State of California
Environmental Protection Agency

AIR RESOURCES BOARD

**PUBLIC HEARING TO CONSIDER THE ADOPTION OF EXHAUST
AND EVAPORATIVE EMISSION CONTROL REQUIREMENTS FOR
SMALL OFF-ROAD EQUIPMENT AND ENGINES LESS THAN OR
EQUAL TO 19 KILOWATTS**

FINAL STATEMENT OF REASONS

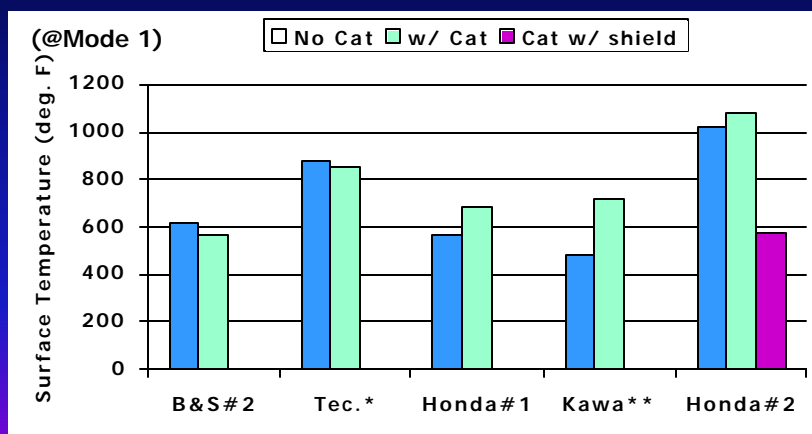
Comment: The Staff Report does not present all the safety data and information presented by numerous experts at the July 2, 2003 ARB public workshop in Sacramento, as well as recent letters from various fire and safety organizations which document technical reasons why ARB must relax the exhaust standards in its August 8th Regulatory Proposal. In fact, the eight hours of testimony at the July 2nd workshop provides a more accurate and complete administrative record (particularly on catalyst-related heat and safety issues) than the relatively short and incomplete summary of issues presented in the Staff Report. First, the Staff Report could be misinterpreted as implying the ARB/SwRI test program showed only a relatively modest temperature rise in the tested catalytic exhaust systems. However, at the July 2nd workshop, manufacturers suggested (through thermal imaging) that SwRI did not test the hottest areas around the catalyst, which generate the most significant heat. Unfortunately, SwRI only measured the much cooler air at a different part of the exhaust stream. This undermines the credibility of SwRI's heat testing and related conclusions.

Second, in the Staff Report, ARB cites to only "one set" of flawed test results from the SwRI study which did not show a significant temperature rise on that one catalyzed engine. However, at the July 2nd workshop, manufacturers documented that even ARB's understated heat measurements showed temperature rises of over 350°F for several tested catalyzed exhaust systems.

Oxidation of HC and carbon monoxide (CO) is an exothermic reaction, and the heat it generates, along with any enrichment of the air-fuel ratio to further reduce engine out emissions could lead to increased exhaust gas temperatures and catalyst/muffler skin temperatures. Manufacturers have raised concerns over safety due to a potential for increased heat generation from the use of a catalytic converter, which could occur if additional mitigation measures are not performed. Manufacturers have noted potential for operator injury from burning, turf browning after engine shutoff in lawn care applications, fire during refueling, and melting of fuel tanks and other plastics incorporated in the equipment. While the American National Standards Institute (ANSI) temperature guidelines vary, OPEI has specifically indicated to staff that individual manufacturers frequently prefer to adhere to heat exposure temperature limits in the range of 150 degrees Fahrenheit. A study conducted by the San Dimas Technology and Development Center, which is a unit of the United State Department of Agriculture Forest Service, indicates that grass

clippings can ignite if they come into contact with surfaces above 518 degrees Fahrenheit.

In response to issues concerning the potential for high exhaust temperatures, the ARB sponsored testing at SwRI included many temperature readings of both current engine designs and the catalyst equipped prototype designs. SwRI engineers used good engineering principles in determining where to place the thermocouples to appropriately measure muffler/catalytic converter skin and exhaust temperatures. Testing at SwRI indicated existing muffler skin temperatures already reached levels in excess of 500 degrees Fahrenheit for walk behind mowers. Currently, manufacturers use muffler heat shields to prevent contact with the muffler. Thus, in response to the commenter's concerns, there are no technological barriers, which would prevent manufacturers from using similar shielding for engines with mufflers containing catalysts. As part of the SwRI test program, the catalyst system equipped engines were tested for their full useful life to ensure that the engines and catalyst systems would maintain emissions for the life of the engines, would be durable, and remain within the manufacturer specifications. The testing showed that the catalyst systems generally met these requirements.

The above figure shows that in some cases, the addition of the catalyst did result in slightly increased muffler surface temperatures. Note that for the Briggs engine (“B&S #2”) and the Tecumseh engine, it would appear that the muffler surface temperature actually decreased with the addition of the catalyst. While this is possible depending on how the engine was adjusted prior to testing, staff believes it is more likely due to test variability. It should also be noted that the catalyst efficiencies observed in the SwRI test program are much higher than those expected to be required to meet the adopted emission standards. Specifically, in the SwRI program, catalyst efficiencies were shown to be as high as 70 percent. The catalysts used by manufacturers to meet the adopted standards would likely have efficiencies on the order of 35 percent. This difference is significant because if the required catalyst efficiency is decreased, the exothermic reaction correspondingly decreases which in turn results in a much smaller increase in exhaust temperatures. Staff contends that this should eliminate any significant safety concerns raised by industry. This was confirmed by Honda in its testimony to the Board in September 2003 in support of staff’s proposal. In part, Honda testified that “We think that the modified exhaust emissions proposal presented today of 10 and 8 grams will make it possible to have an exhaust system with a lower risk of being a fire safety hazard. It is manageable today on our current products. And with this revised proposal it will be manageable on the future engines. The revised proposal will also be significantly more cost-effective air quality improvement for California. This modification has been a positive and very helpful change. While there is always risk, even on today’s products, due to their diversity of use or even misuse in their application, we do not believe that the staff proposal presented here today for future exhaust emission standards will have a significant impact on the safety of our future engines in comparison to current engines or products.” Thus, while staff believes that in some cases, the increase in temperature will be small, on the order of less than 50 degrees Fahrenheit, in other cases, it may be somewhat higher. Briggs provided a presentation at the July 2, 2003 public workshop which showed a peak surface
